PRIORITY DEVELOPMENT PROJECT (PDP) STORM WATER QUALITY MANAGEMENT PLAN (SWQMP)

FOR
SUMMIT AVENUE
TM-2023-0003
10939 Summit Avenue
Santee, CA 92071

This PDPSWQMP presents a revision to the December 19, 2024 report pursuant to the City of Santee plan check comments received January 20, 2025. The following text identifies the plan check comments along with the responses in bold.

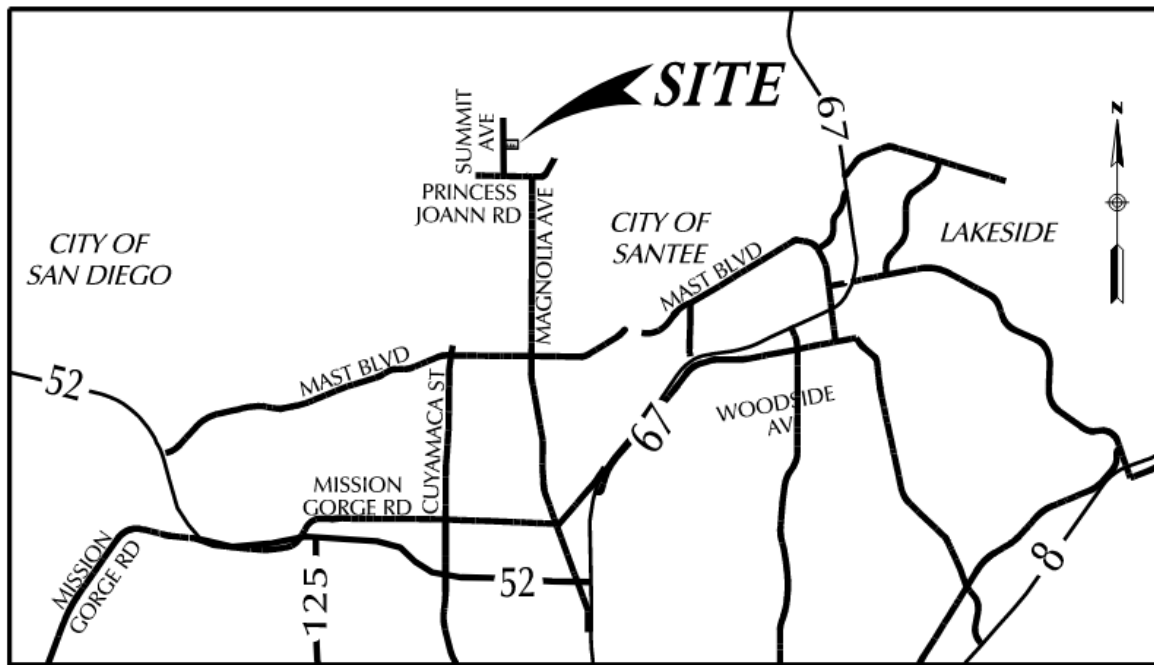
50. (Page 68) Hydromodification Post Project Exhibit – Depict the non-vegetated channel as seen in the VTTM sheets.

The non-vegetated channel is not part of project improvements and outside project's boundary. Callout has been added accordingly.

DRAINAGE MANAGEMENT EXHIBIT FOR SUMMIT AVENUE

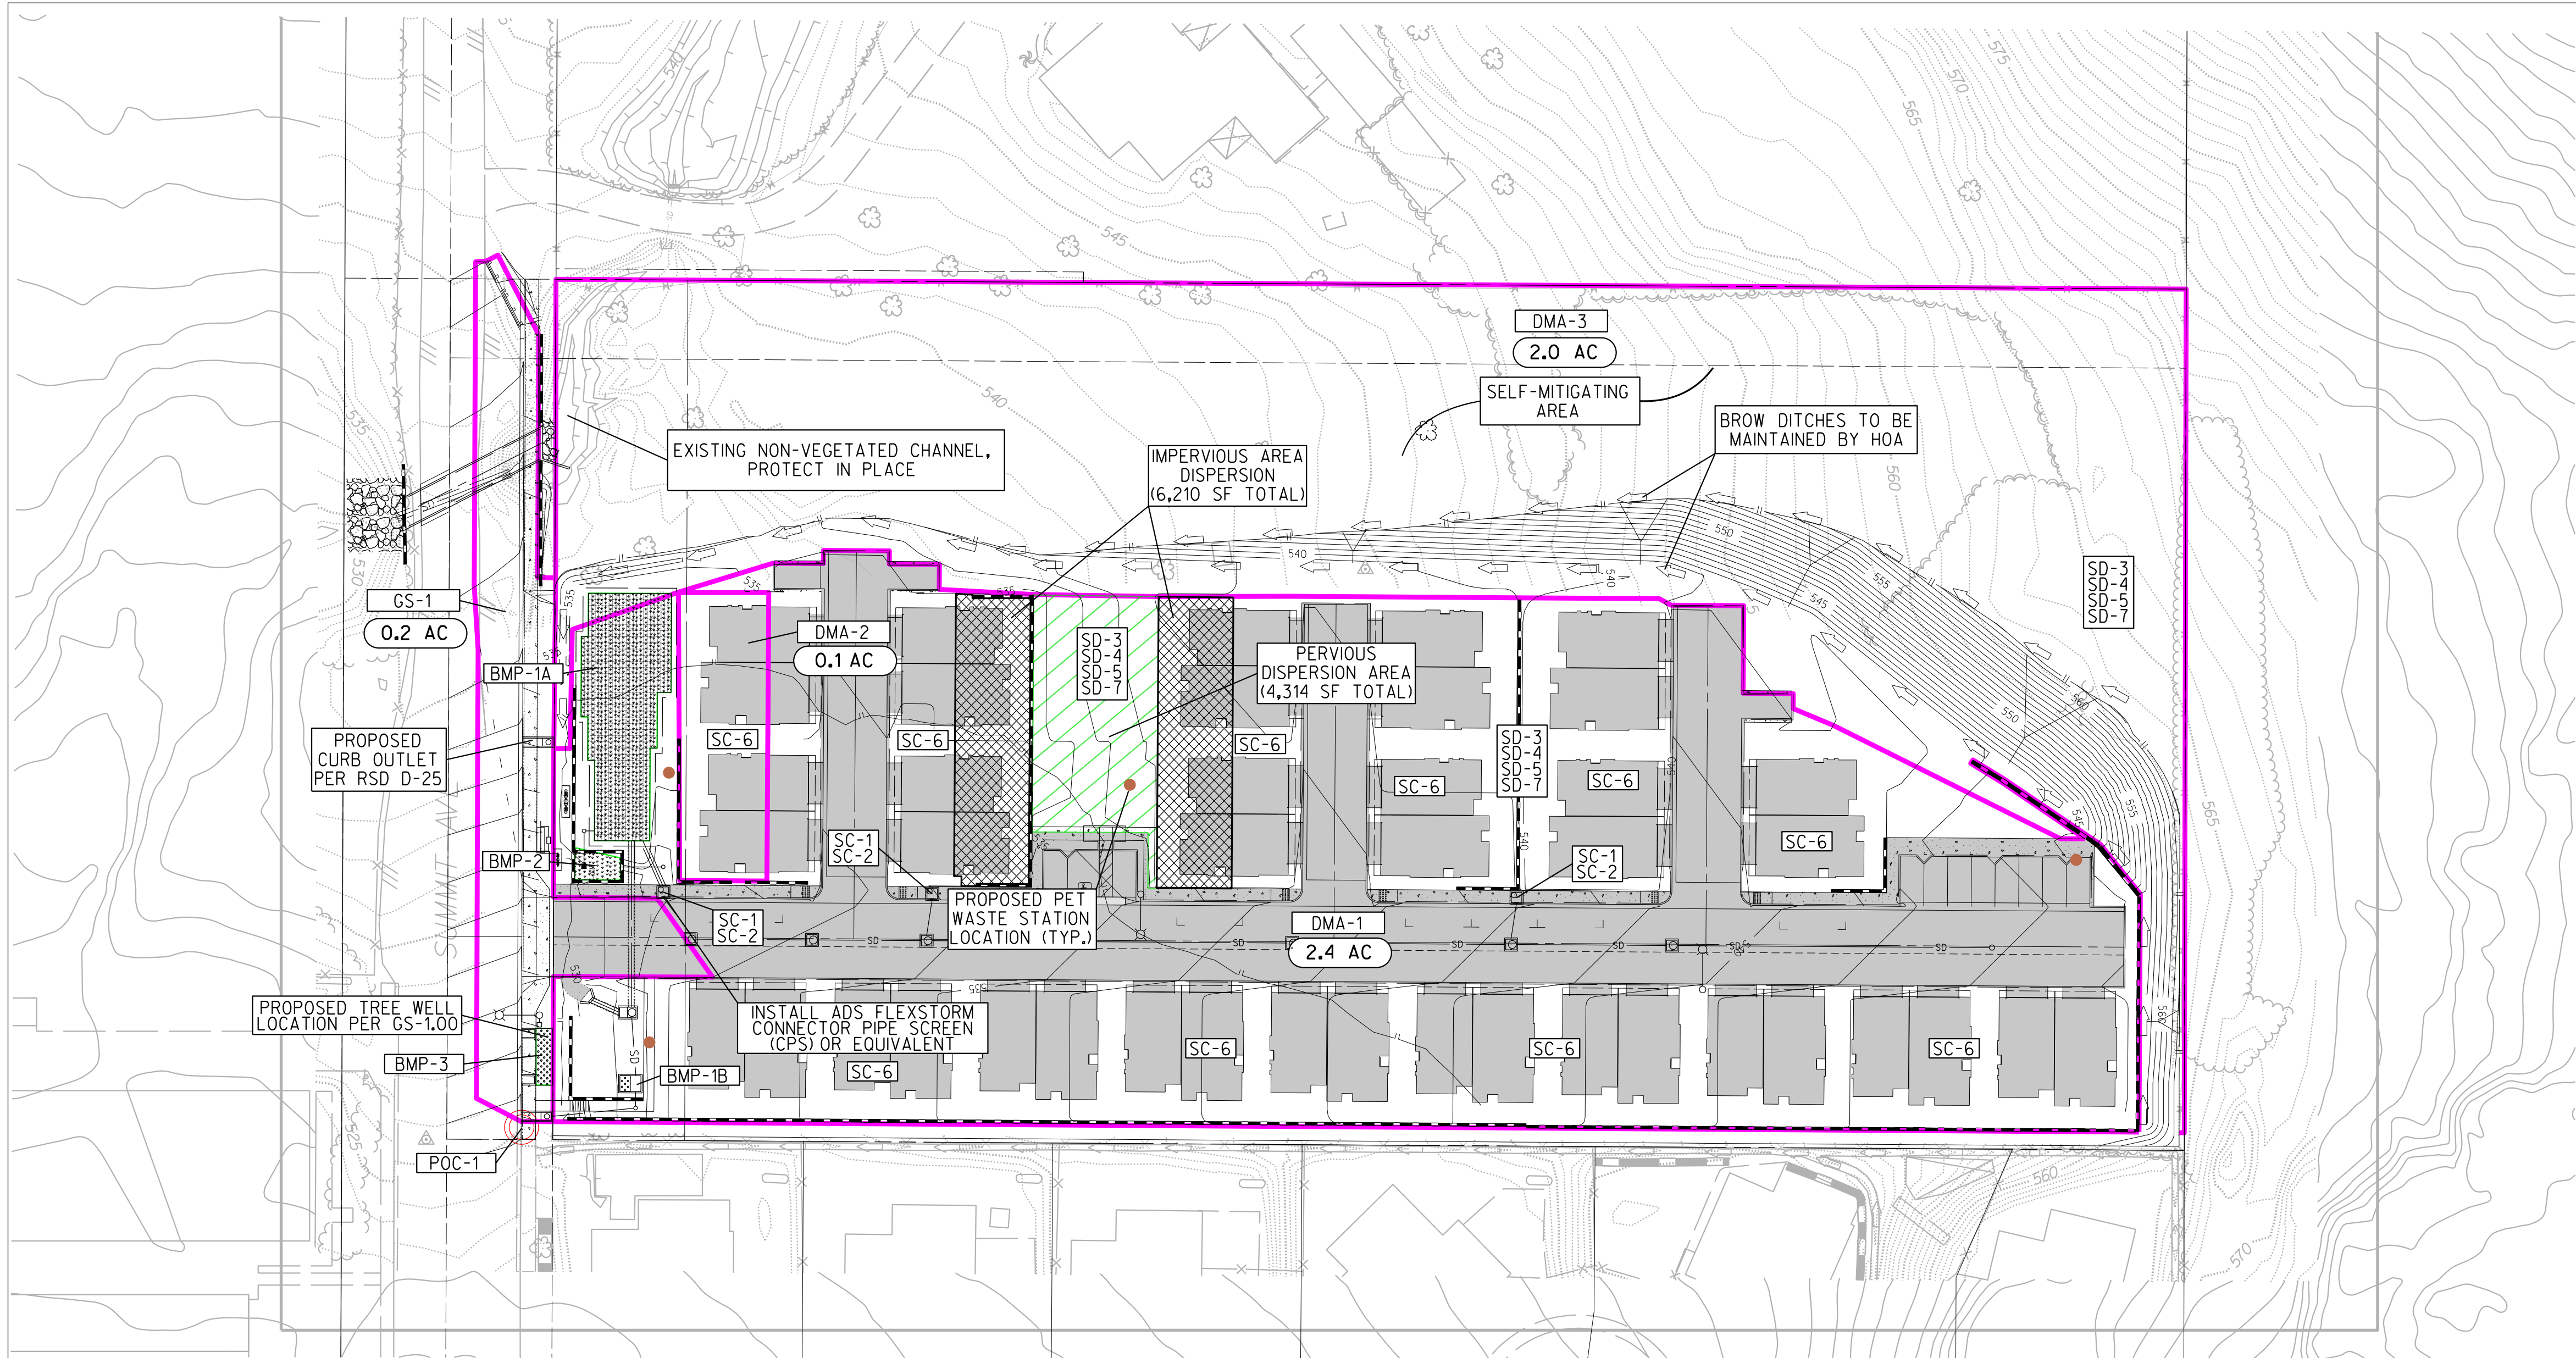
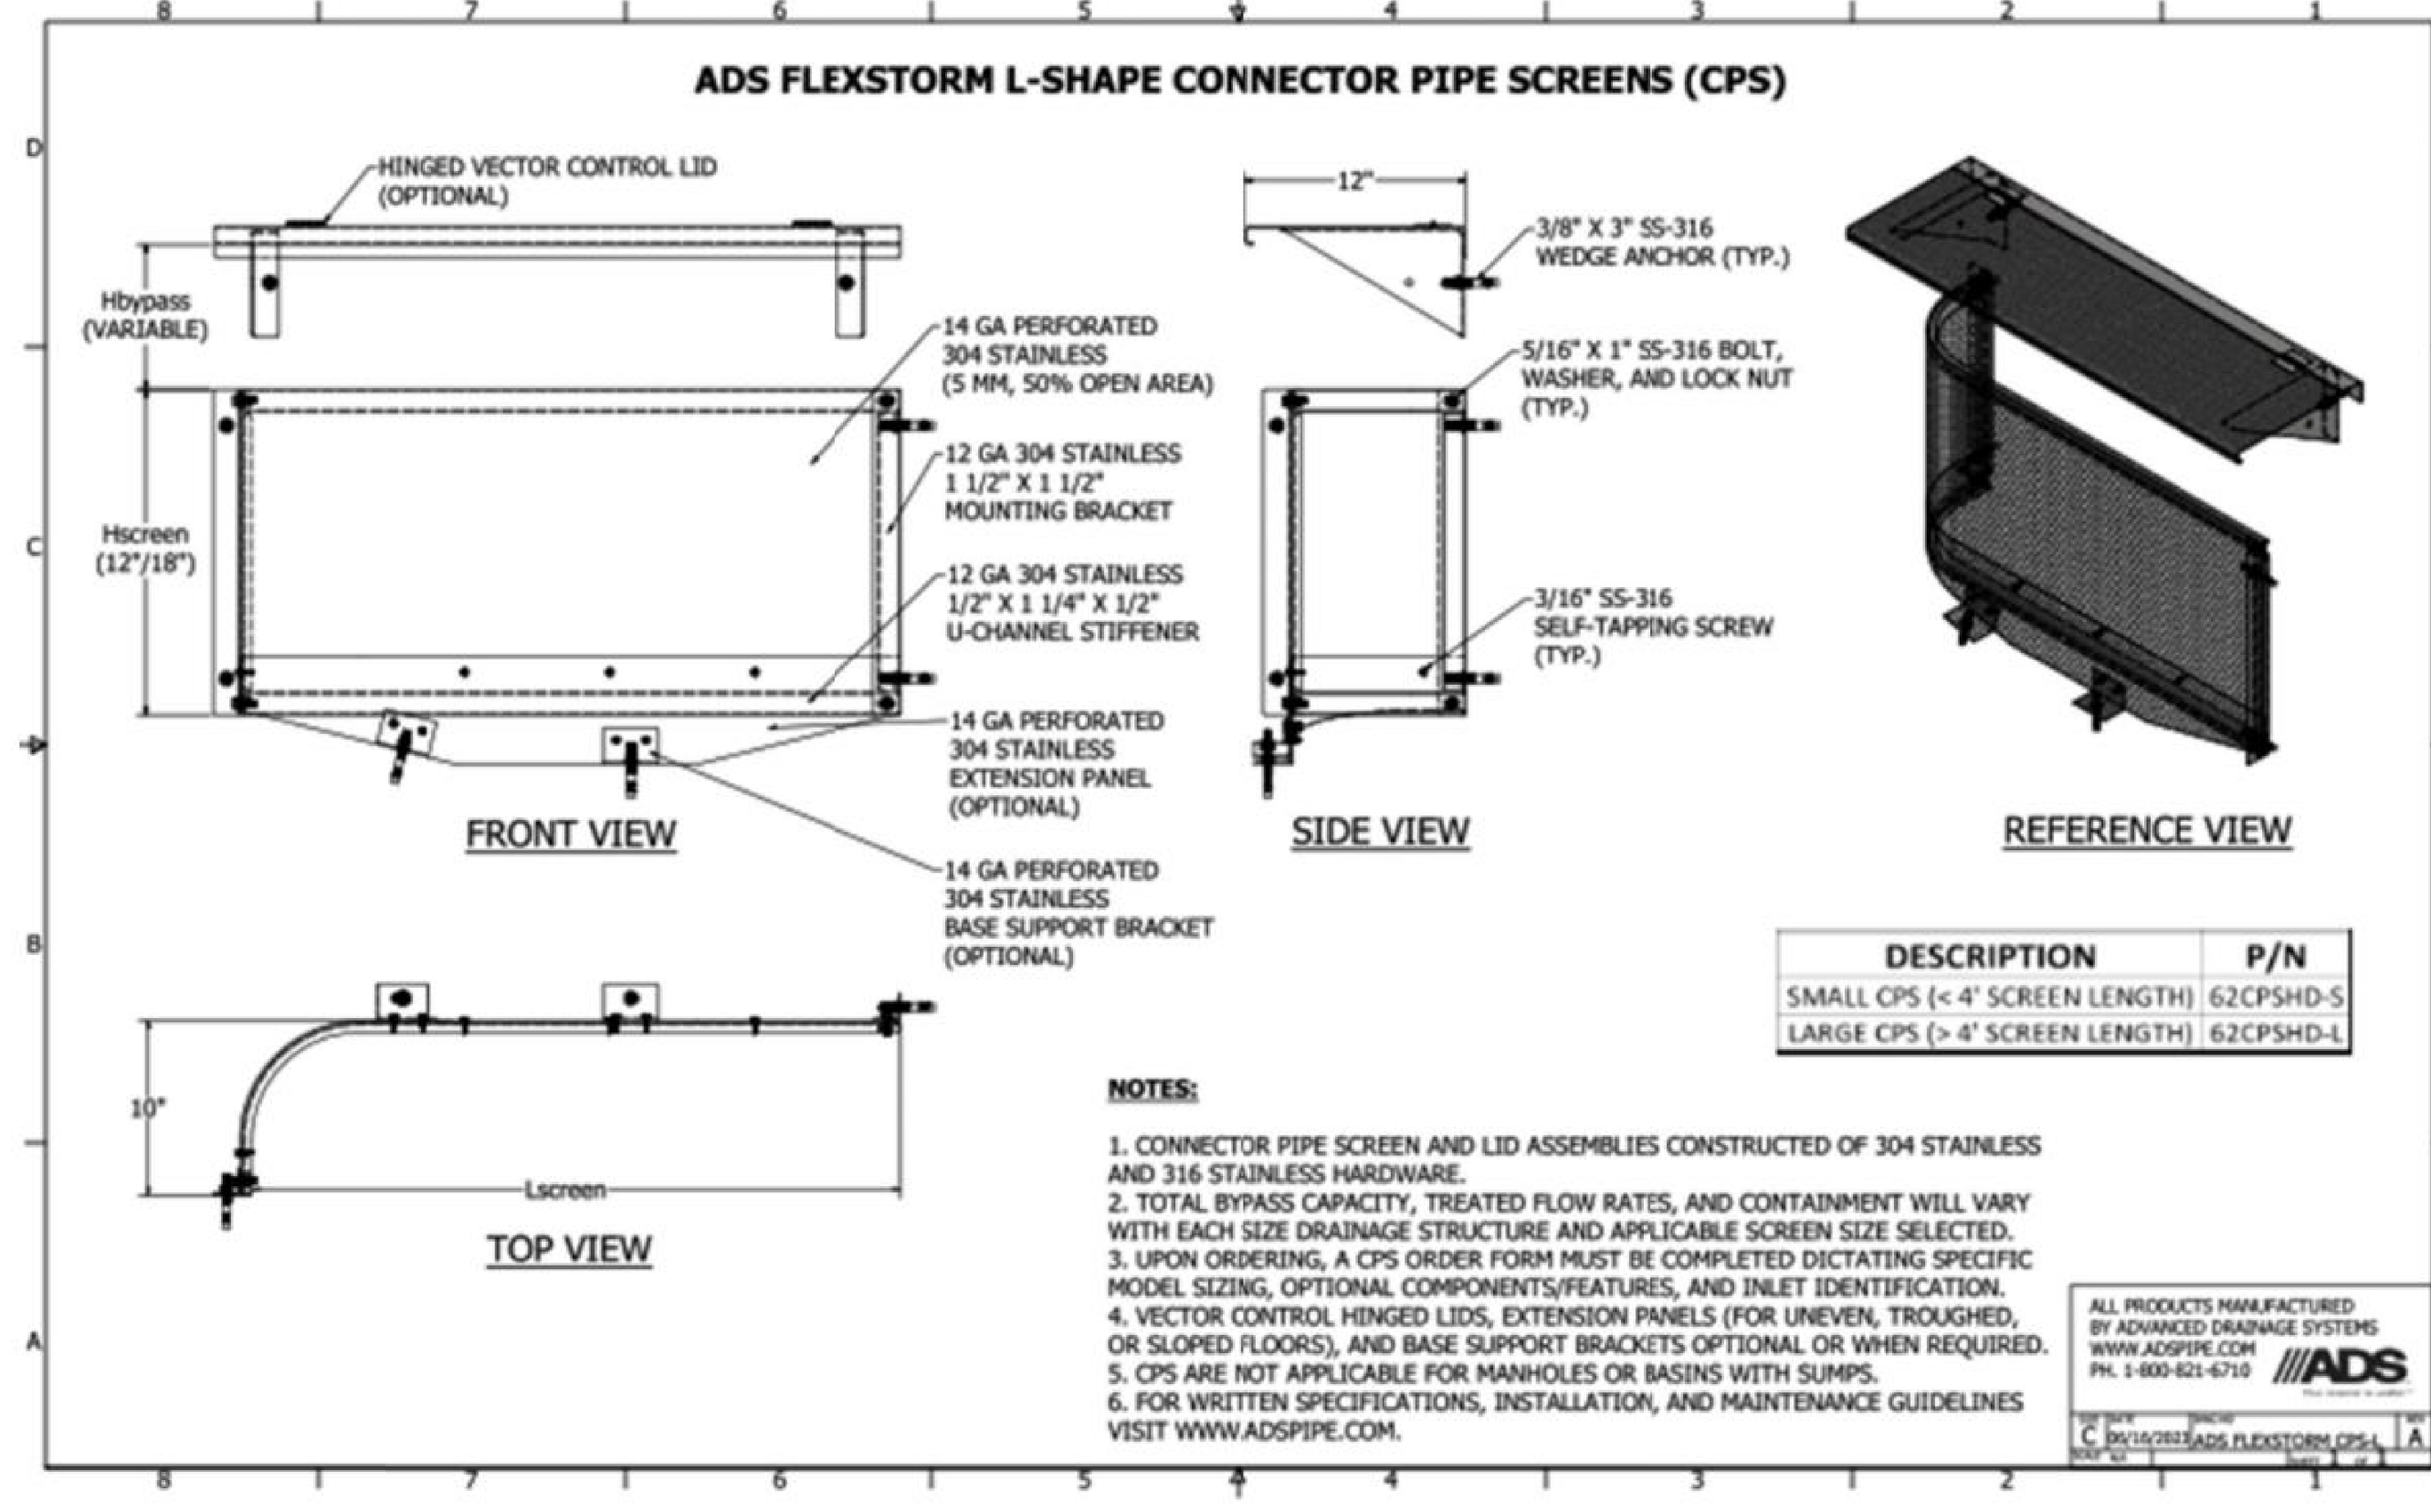
2j i. Storm Water Quality Management Plan: Page 48 (DMA Exhibit): Update exhibit to include a DMA for the northern portion of the parcel. Suggest identifying it as self-mitigating.

2j iv. Storm Water Quality Management Plan: Page 48 (DMA Exhibit): Color-coordinate/update exhibit to differentiate between pervious and impervious features.

2j vi. Storm Water Quality Management Plan: Page 48 (DMA Exhibit): Call out/identify locations of all full trash capture devices. Currently, the exhibit only calls out one.

2j ix. Storm Water Quality Management Plan: Page 48 (DMA Exhibit): Call out/identify locations of pet waste stations. Include details of the pet waste stations to the sheet including make, model, example signage, etc.

2j x. Storm Water Quality Management Plan: Page 48 (DMA Exhibit): Add details of each BMP (vault, MWS, tree well, full trash capture device) to the sheet.

2j xii. Storm Water Quality Management Plan: Page 48 (DMA Exhibit): Add a note about the non-vegetated channel to the “Notes” section on the exhibit.

2j xiii. Storm Water Quality Management Plan: Page 48 (DMA Exhibit): Add a brow ditch icon to the legend.

2jxiv. Storm Water Quality Management Plan: Page 48 (DMA Exhibit): Add a note about the HOA being responsible for maintenance of the pet waste stations.

Exhibit updated to add a Self-mitigating DMA to northern area within parcel.

Impervious hatch added to exhibit to identify impervious area. Pervious areas remain unhatched.

Only one trash capture device is proposed – at the most downstream curb inlet prior to entering the Storm Trap Vault. Pipe screen or equivalent callout added.

Pet Waste Station symbol and callout added to DMA exhibit. Locations were determined per the BMLA Conceptual Landscape Plan, dated 1/29/2024. Pet Waste Station details (make, model, example signage, etc.) to be provided in Final Engineering.

Preliminary MWS Detail and Tree Well Detail added to DMA Exhibit. Vault Detail and Trash Capture Device Detail to be provided in future submittal.

Discussion of non-vegetated channel added to DMA Exhibit Notes.

Brow ditch icon added to legend.

Note 10 added to DMA Exhibit - "HOA to be Responsible for Maintenance of the Pet Waste Stations".
